## ADDENDUM NO. 1

PROJECT: Saline Area Schools – 2022 Bond Program – MS Rec Complex  
 DESCRIPTION: Addendum No.1  
 BID PACKAGE RELEASE NUMBER: BP #3

1. ADDENDUM No. 1, November 20<sup>th</sup>, 2024 as issued by Kingscott (Attached)
2. Bid Package T4 Draft Drawings, October 22<sup>nd</sup>, 2024 - Saline Middle School Rex Complex as issued by Barton Malow (For Reference Only)

SHEET NO.  
**C3.10**  
KINGSCOTT ASSOCIATES INC. KALAMAZOO, MICHIGAN

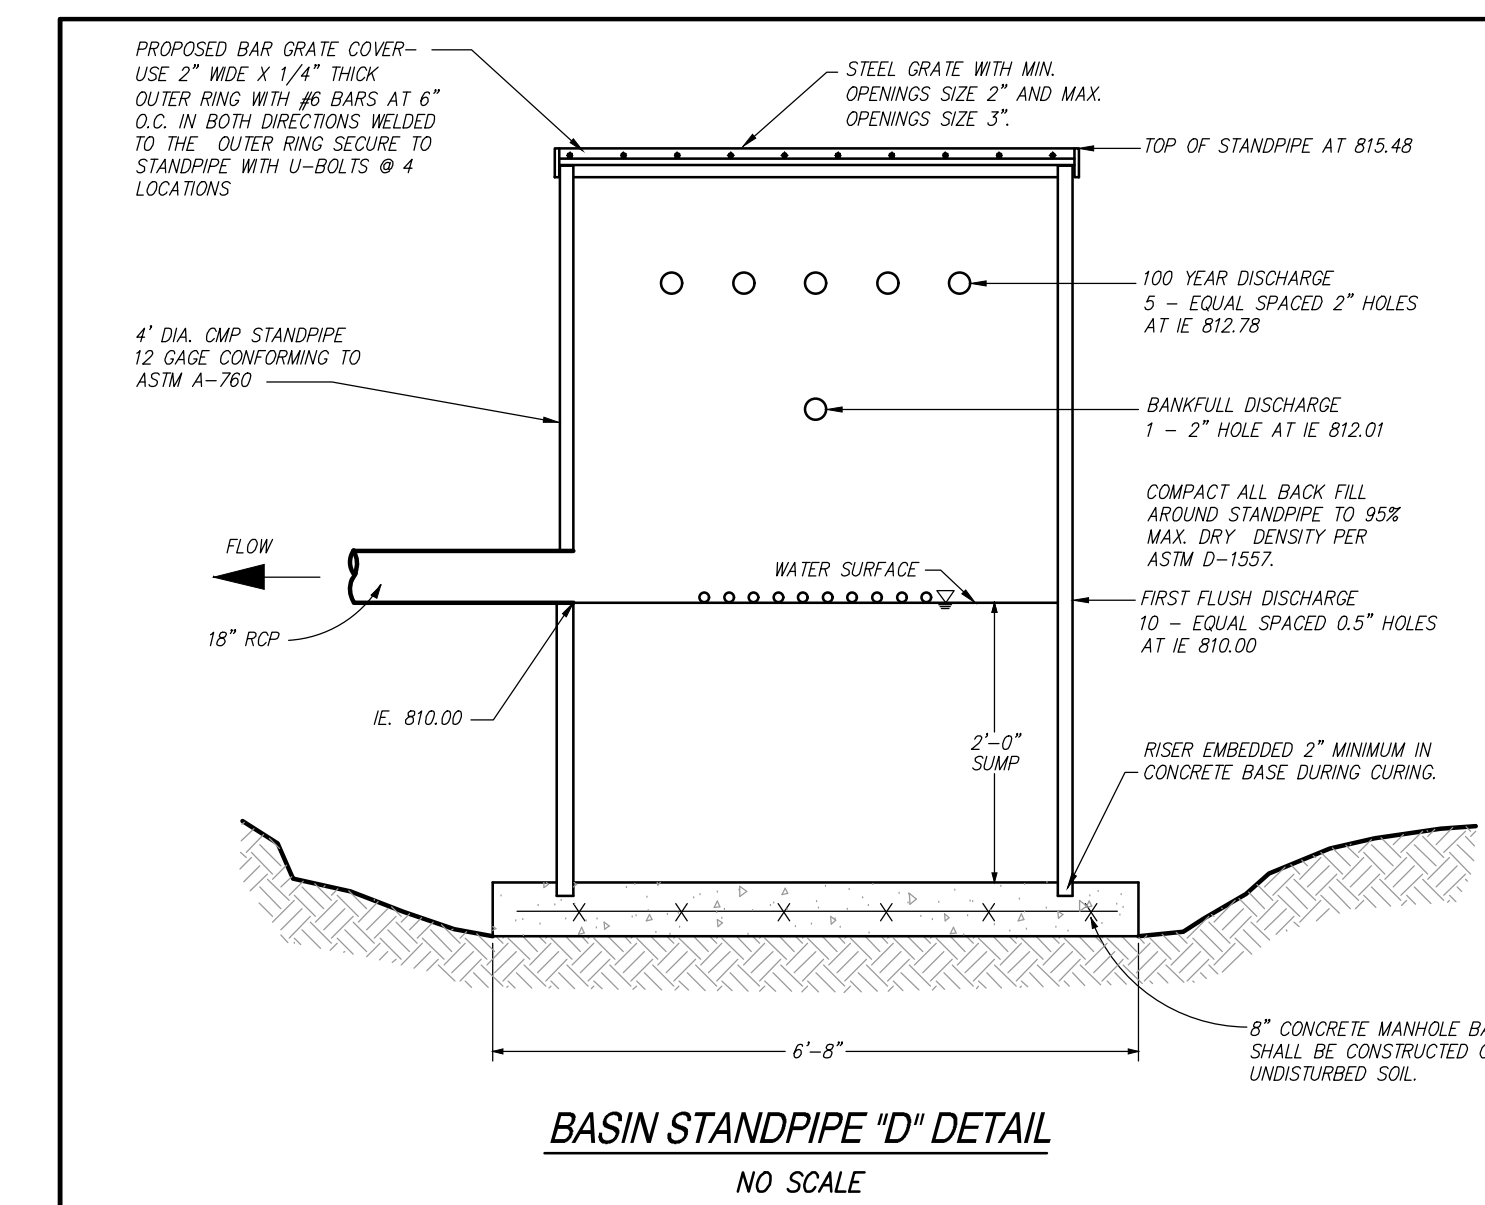
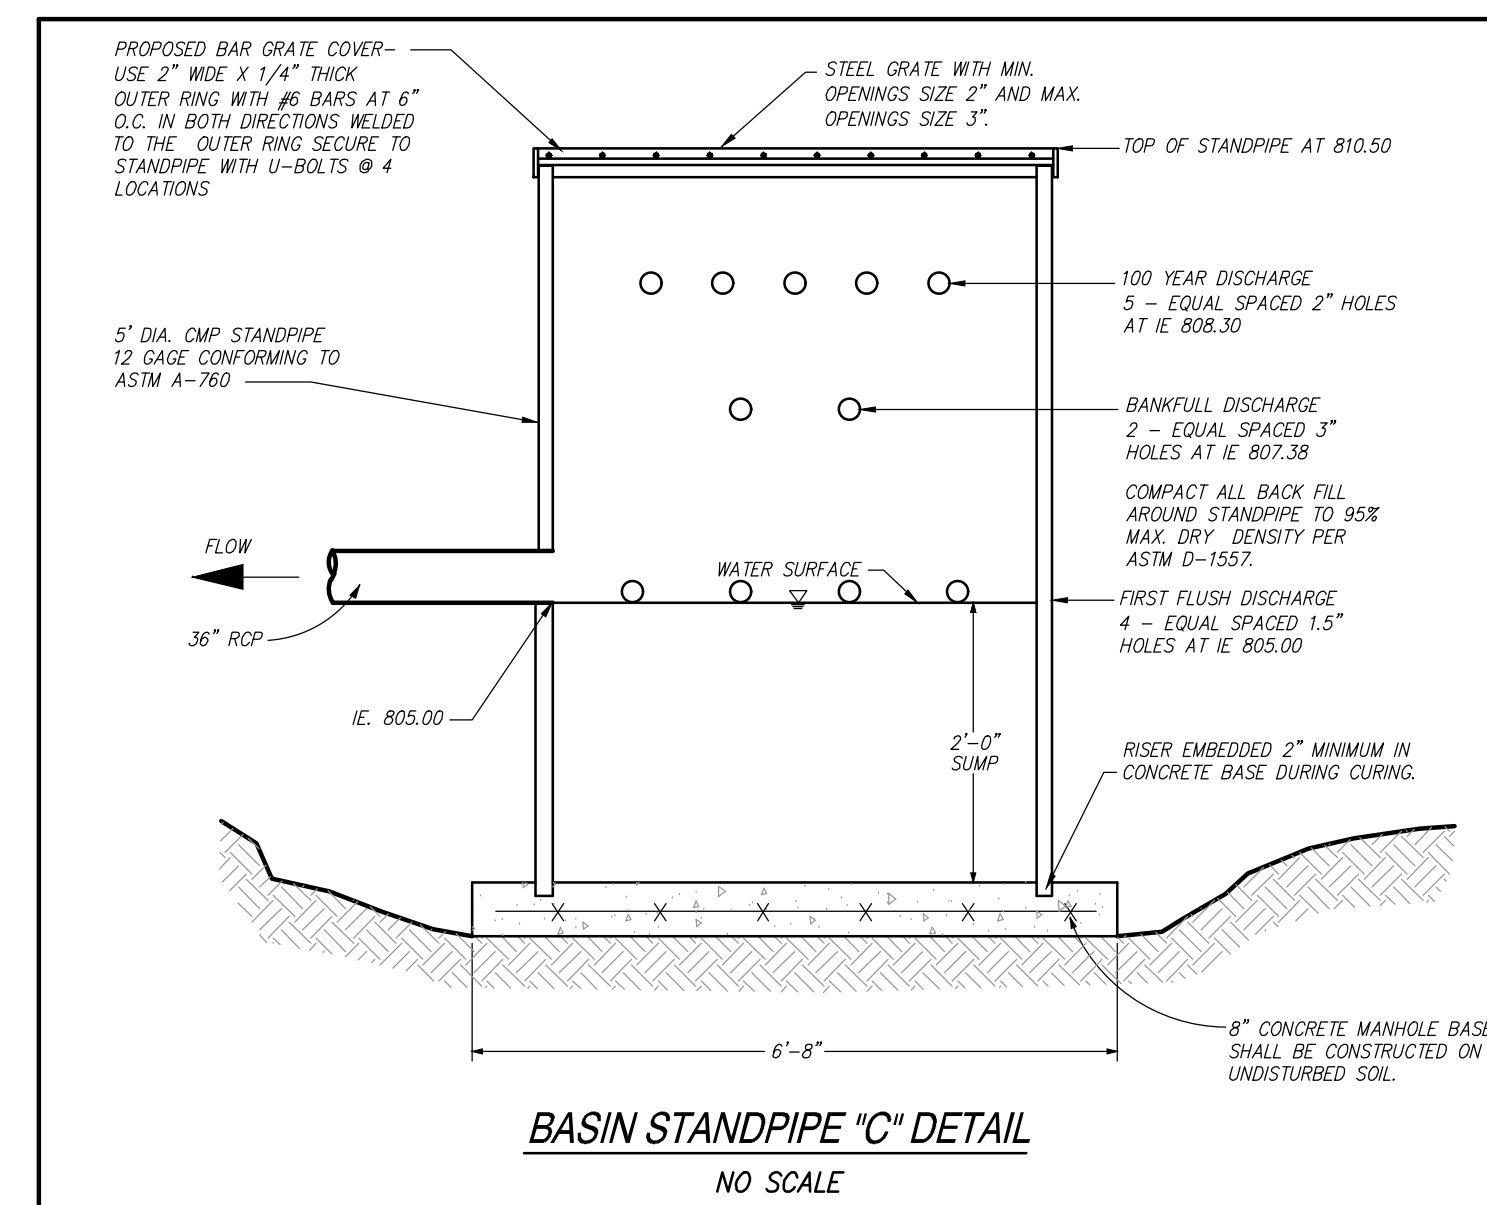
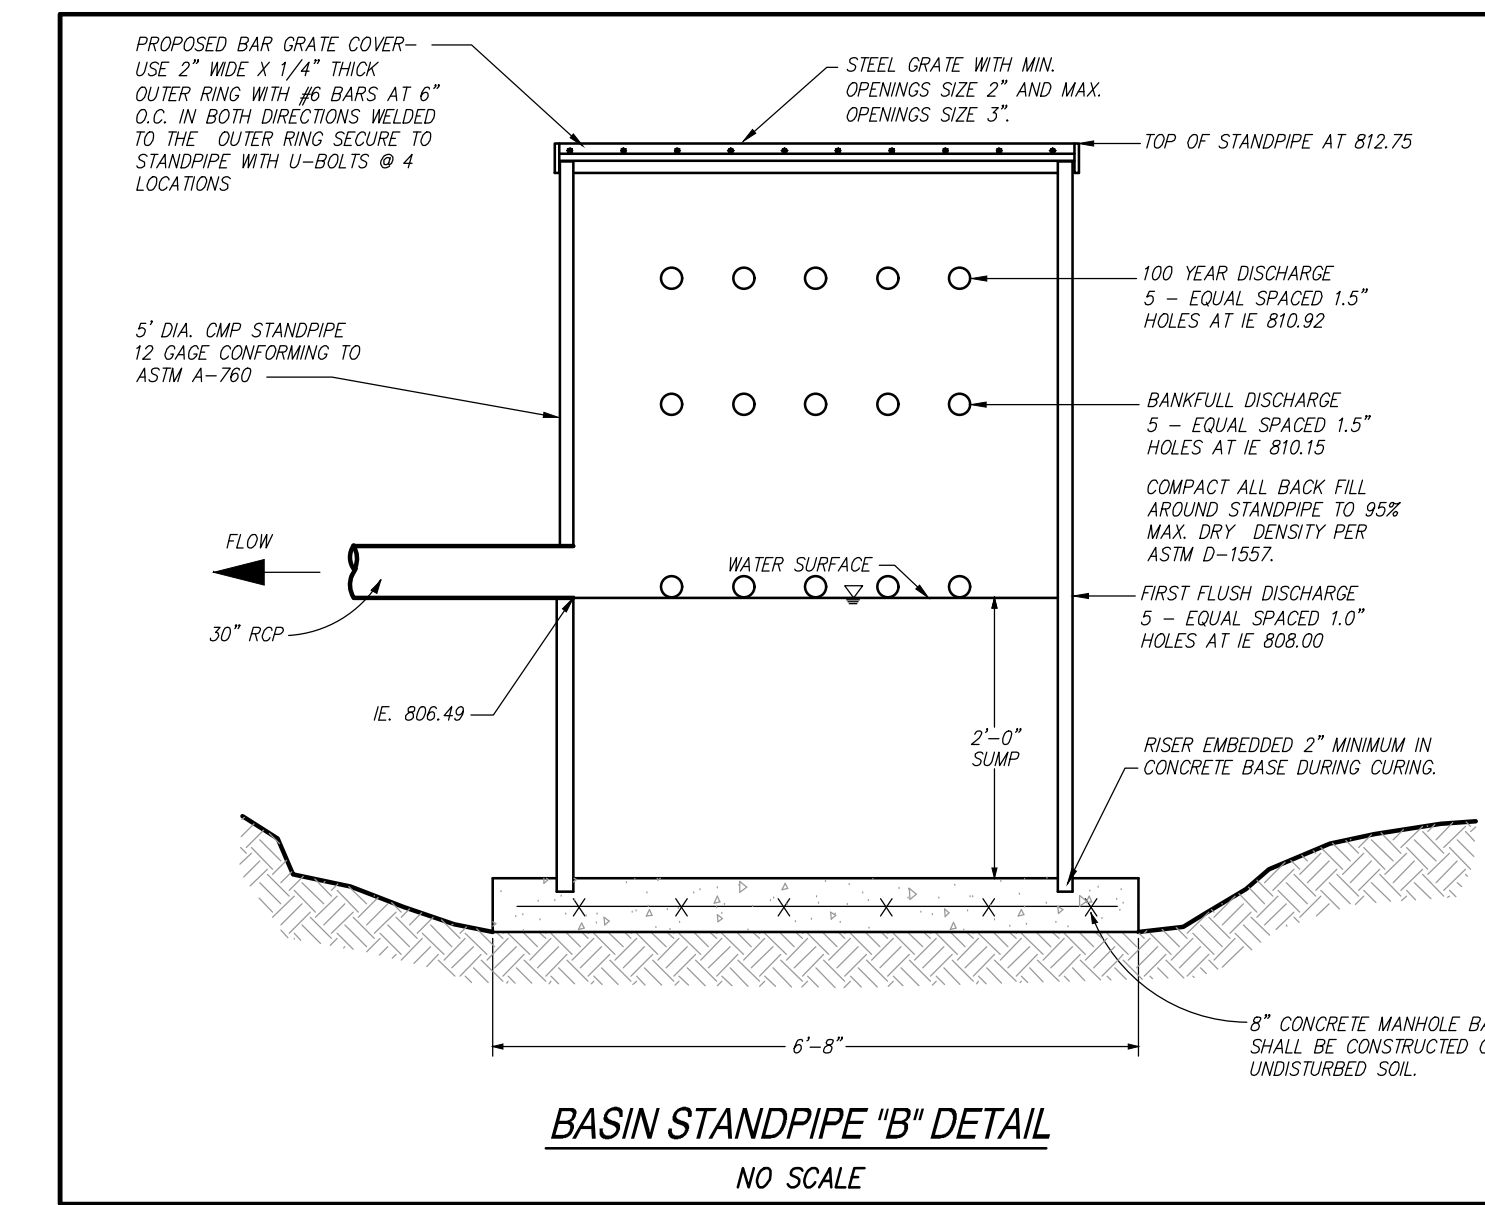
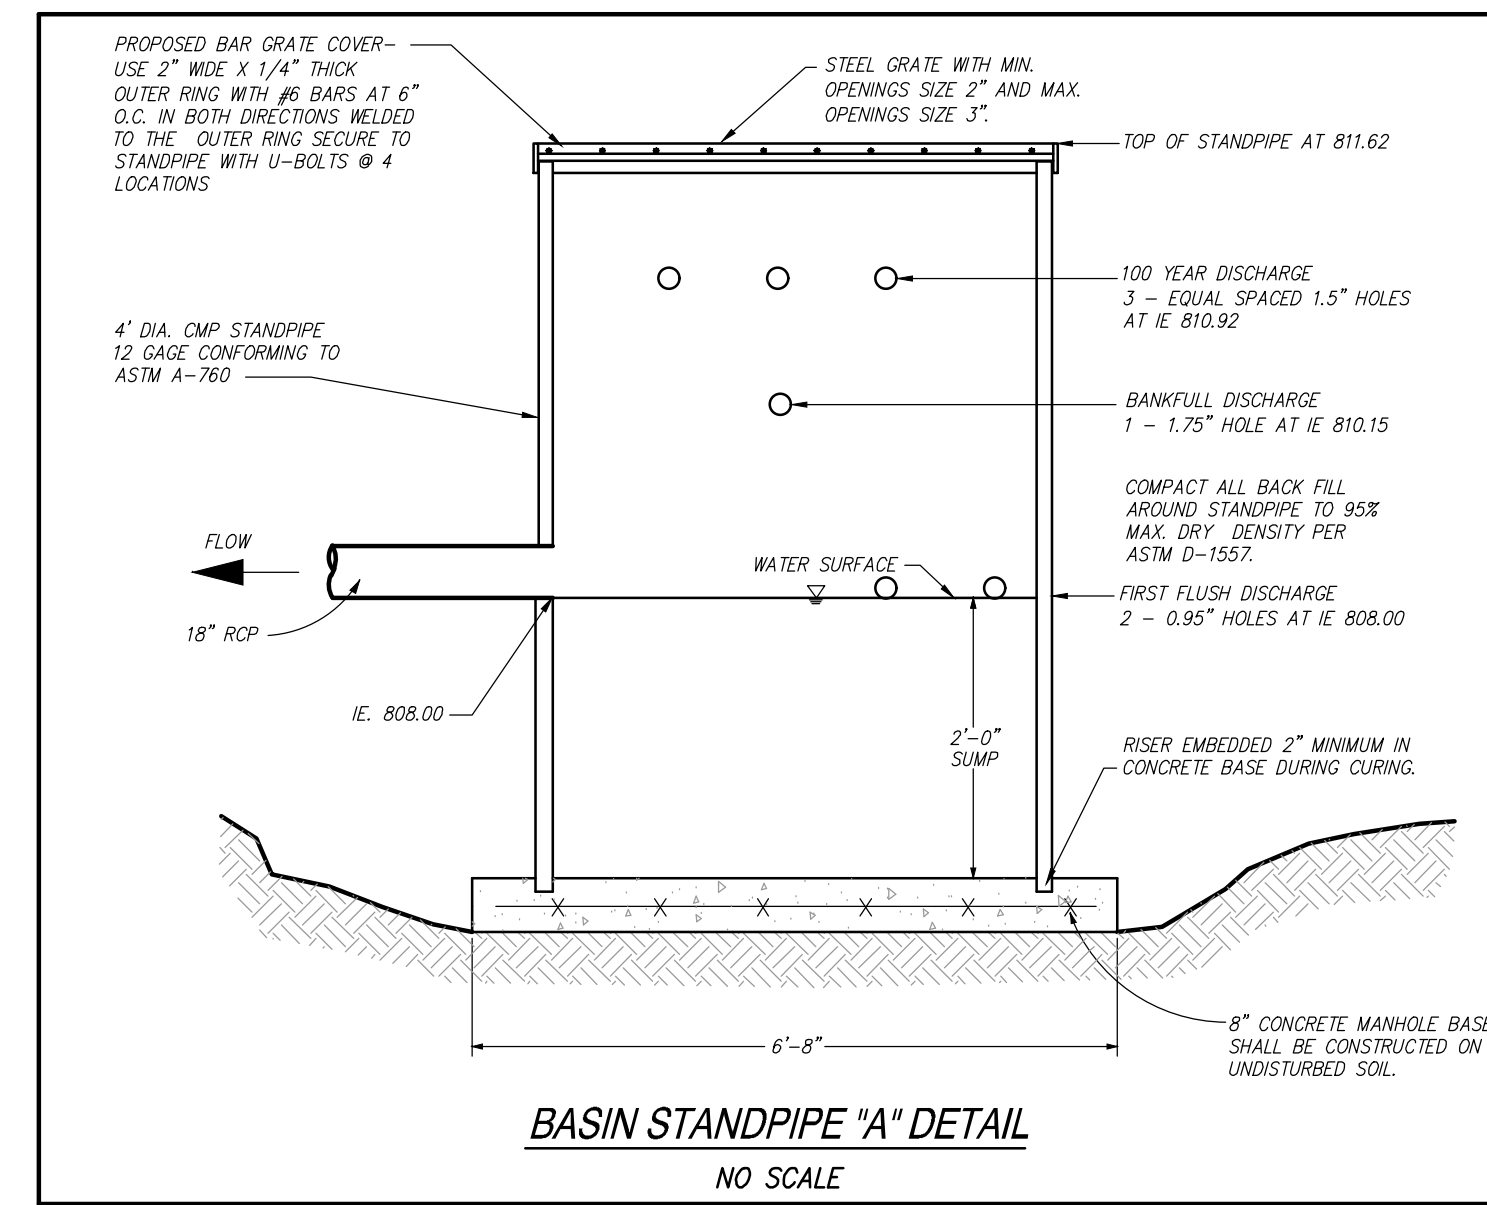
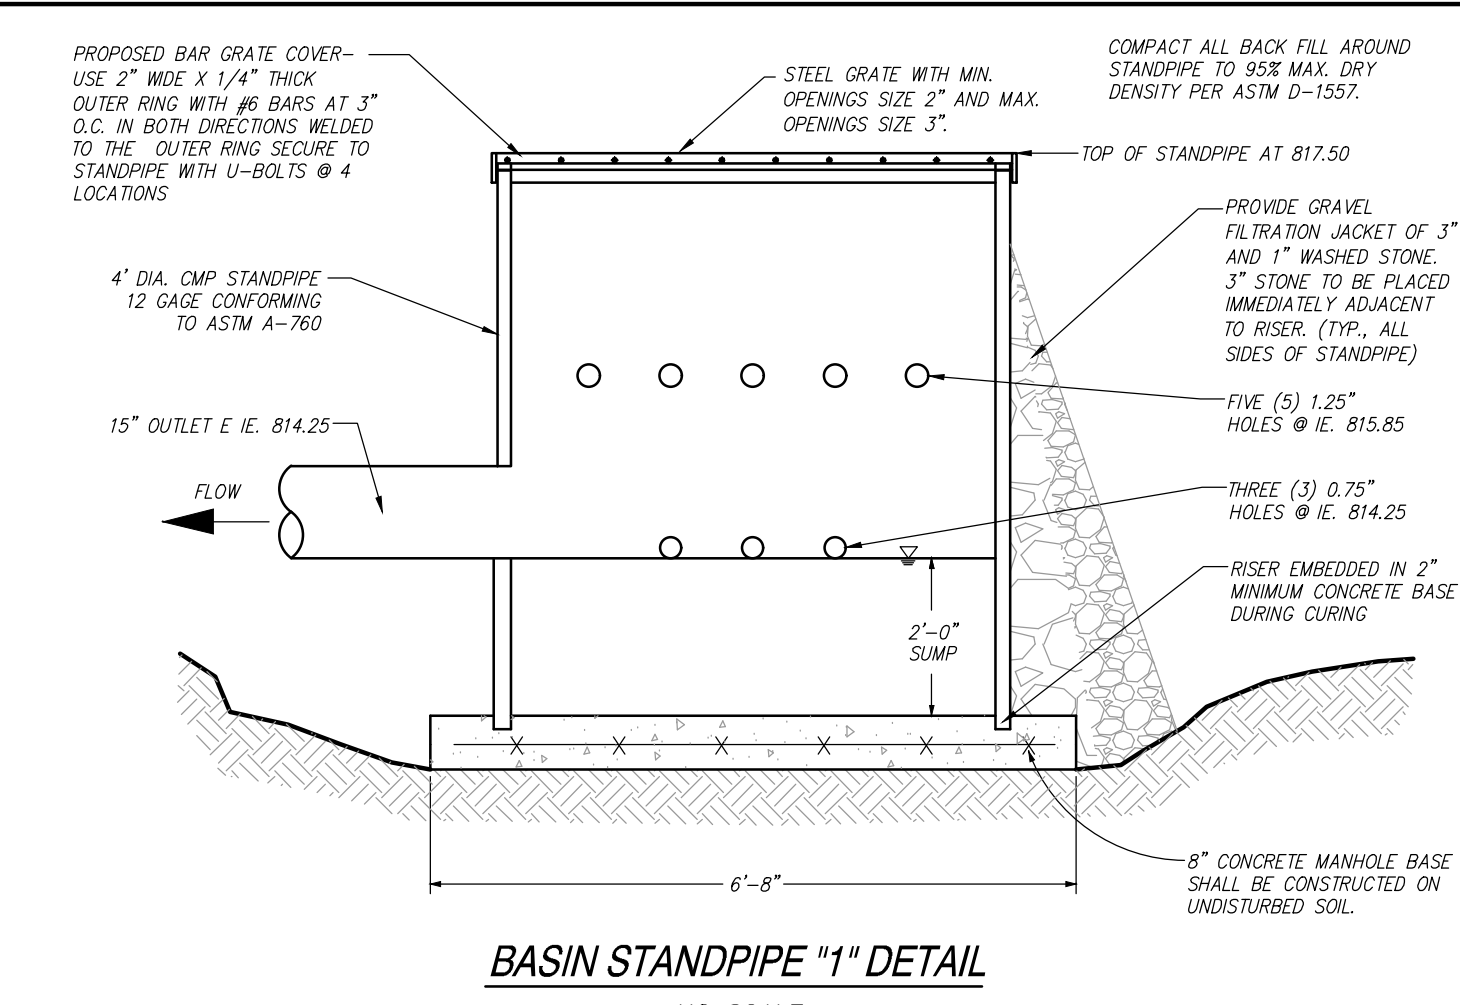
- Item No. 50: Updated Storage Volume Calcs and Standpipe details on sheet C3.10.
- Item No. 51: Added proposed basin storage tables to sheet C3.10.
- Item No. 52: Updated OMP per basin and utility layout changes on sheet C3.11.
